RENESAS TECHNICAL UPDATE

Product Category	Application specific IC		Document No.	TN-ASP-A020A/E	Rev.	1.00
Title	M66591 Usage Precautions of the Buffer memory initialization by the ACLRM bit		Information Category	Technical Notification		
Applicable Product	USB ASSP M66591	Lot No.	Reference Document	M66591 data sheet (REJ03F0101)

* When used on Bulk IN transfer (theoretical figure)

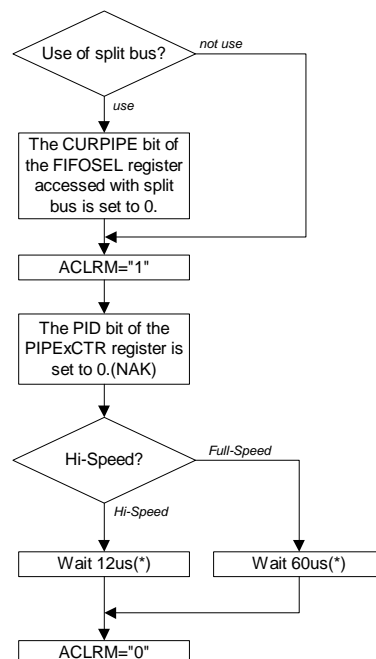
1. Phenomena

This precaution concerns the Buffer memory initialization by the ACLRM bit.

When the conditions described in [2. Occurring Conditions] below are met, the Interrupt status of the pertinent pipe cannot operate properly.

2. Occurring Conditions

[1. Phenomena] described above may occur when condition 1 is present at the same time as condition 2 or 3.

Condition 1: The ACLRM bit is set to "1" and then to "0".

Condition 2: During a USB communication.

Condition 3: During an access by using Split bus.

3. Solutions

This phenomenon can be avoided by using the following software flowchart.
